2017/11/23

MVSC-300/460-4E2C/P/R, MVSN-300-4E2C/P/R Solenoid valve and
MVAA-300/460-4A2C/P/R Pneumatic valve
Double-sided set body change to single-sided set body

MVSC-300/460-4E2C/P/R, MVSN-300-4E2C/P/R Solenoid valve and
MVAA-300/460-4A2C/P/R Pneumatic valve.

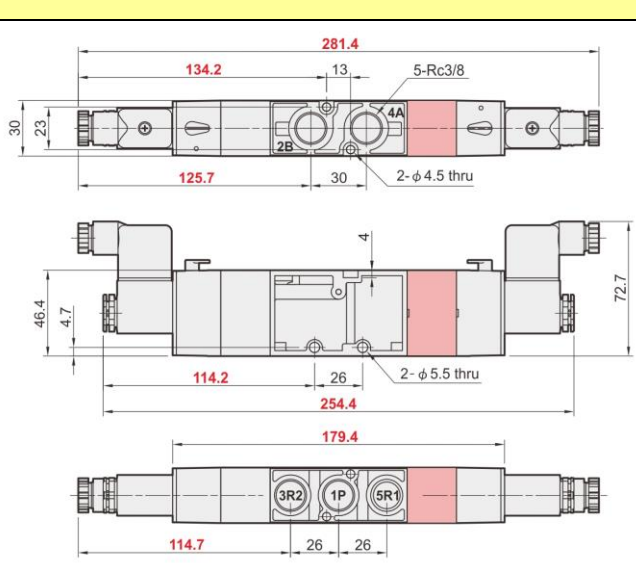
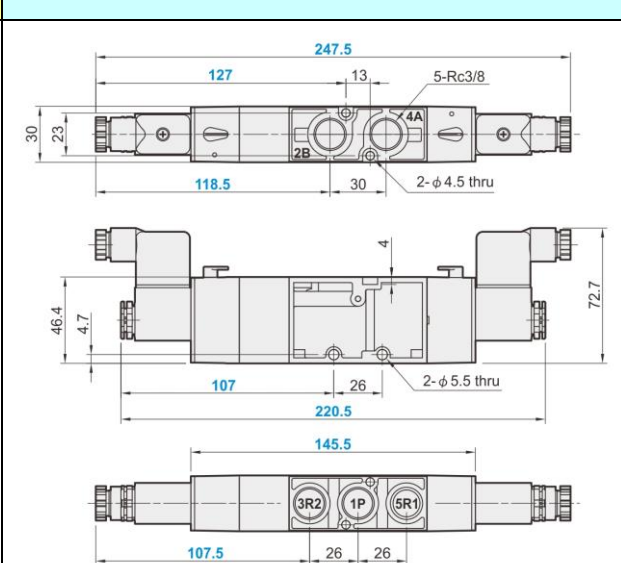
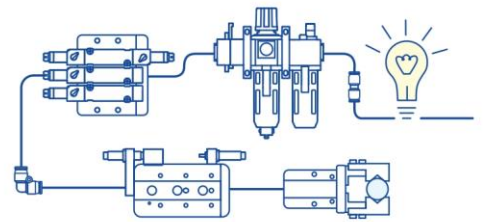
To strengthen product performance, we will change the set body from double side to single side for MVSC-300/460-4E2C/P/R, MVSN-300-4E2C/P/R Solenoid valve and MVAA-300/460-4A2C/P/R pneumatic valve. In this way, the weight of these products will reduce 6-24% and the volume will minify 8-19%.

(1)MVSC-300/460-4E2C/P/R: double-sided set body change to single sided set body (takes MVSC-300-4E2C as example)

(2)MVSN-300-4E2C/P/R: double-sided set body change to single (takes MVSN-300-4E2C as example)

(3)MVAA-300/460-4A2C/P/R: double-sided set body change to single (takes MVAA-300-4A2C as example)
